Common Pluggable Interface

For 100GBASE-CR10 & 100GBASE-SR10

- Objectives
 - Opportunity - Reuse twelve-lane form factor
 - Issue – Lane selection in twelve-lane form factor for ten-lane applications
 - Recommendation
-
- Addresses D2.0 comment 609

Issue

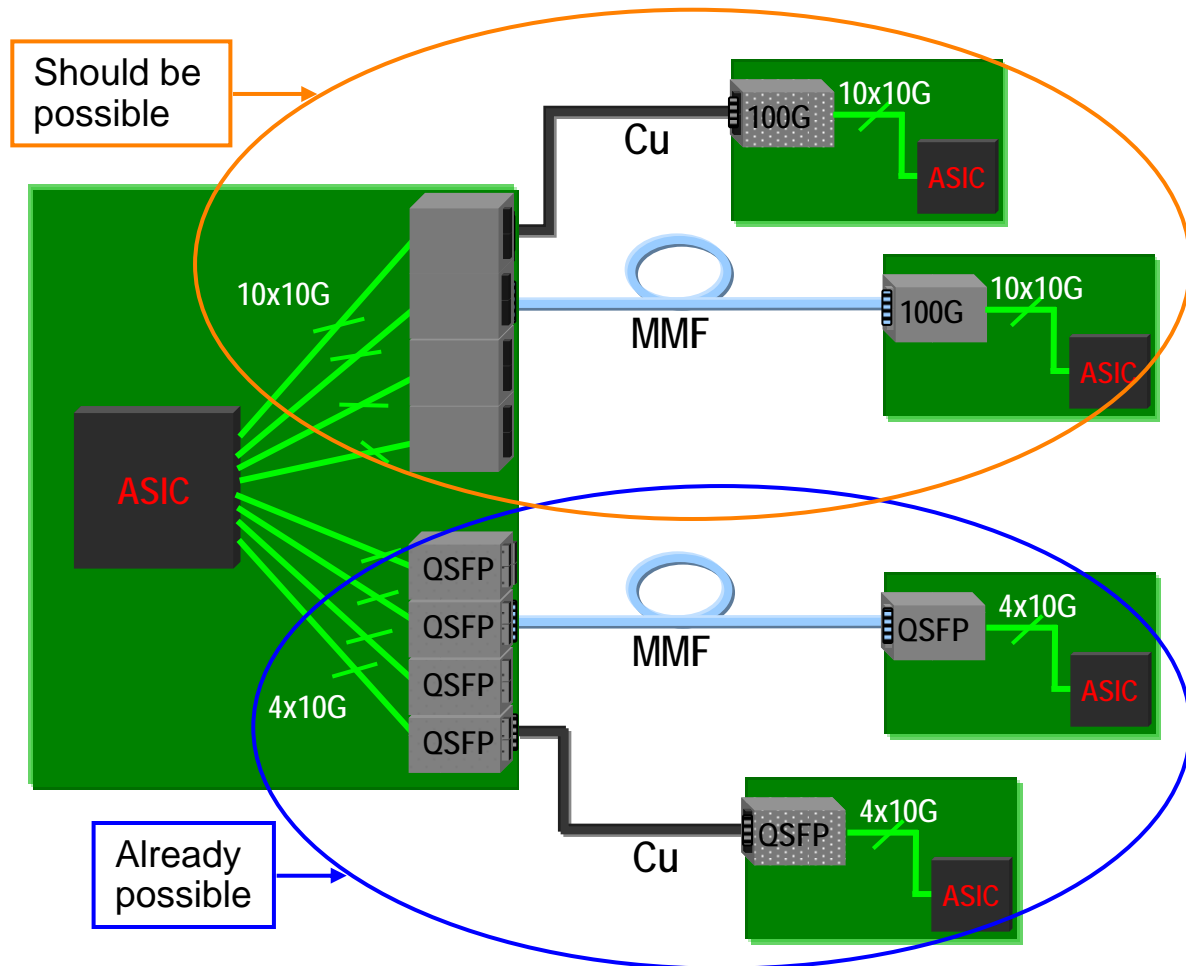
Since 100GBASE-CR10 and 100GBASE-SR10 only use ten of the twelve lanes available lanes in an emergent form factor, a key item is to identify which ten to use. Choosing a common set of lanes for copper and optical variants will enable its reuse for 100GBASE-CR10 and 100GBASE-SR10 applications with minimum additional effort for ASIC and host board designers. Failure to use a common set would be problematic and frustrating for host ASIC and board designers.

If a common set of ten is not used, the host board designer has onerous choices:

- dedicate some specific ports to copper variants and others to optical variants
- route eleven lanes to all ports and require that the ASIC adapt to the variant that is eventually inserted.

If a common set is used, equipment can be more readily designed to have field-configurable ports providing media flexibility to end users.

Recommendation for 10-Lane CXP Applications (2)

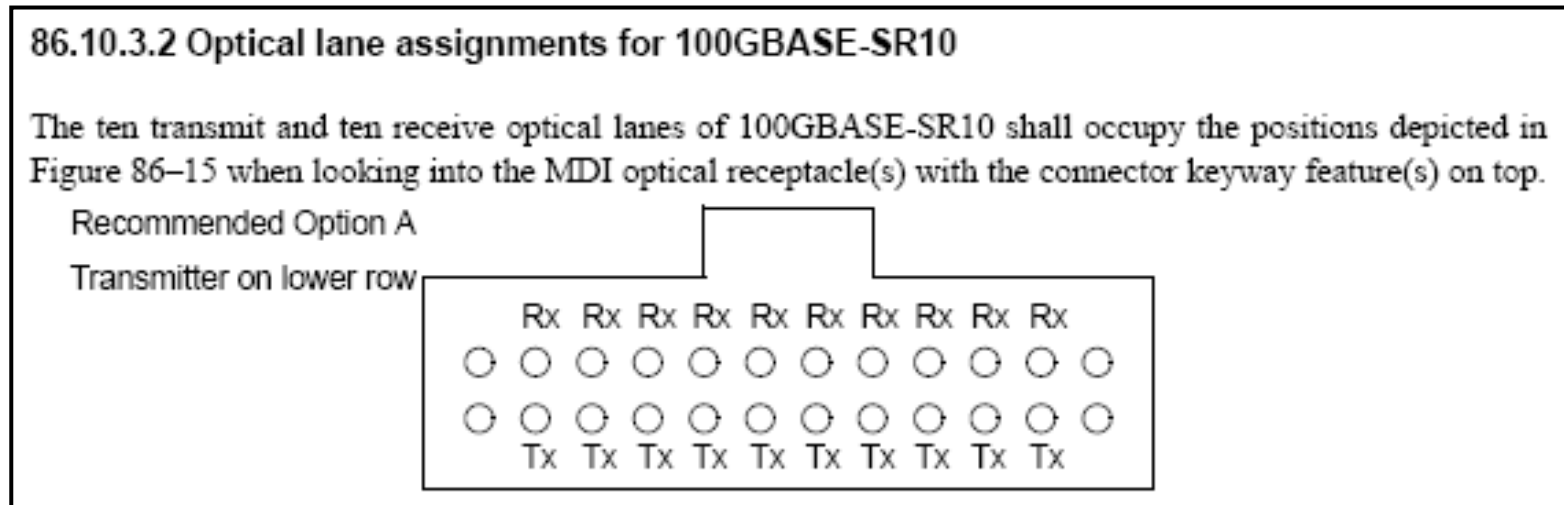
The above image is an excerpt from 802.3ba draft 2.0 showing the choice made in Clause 86. Only the recommended option of the three options in Figure 86-15 is shown. The other two options use two single-row connectors.

The advantages if all variants, copper, active cable assemblies and fiber optics, adopt the above lane selection include:

- Less complicated ASIC – same 10 lanes used for all variants, only 10 lanes require support
- Less complicated host board design – same 10 lanes used for all variants, only 10 lanes require support
- Less complicated modules – mapping between inputs and outputs maintained between 10 lane and 12 lane applications, simplifying a common build standard and lowering costs
- Increased cable plant performance/reliability – for ribbon cables the outmost lane members see the most stress and exhibit the most variability in insertion loss and highest attenuation
- Larger market and earlier adoption – reduced ASIC & equipment design complexity and increased network media flexibility for end user
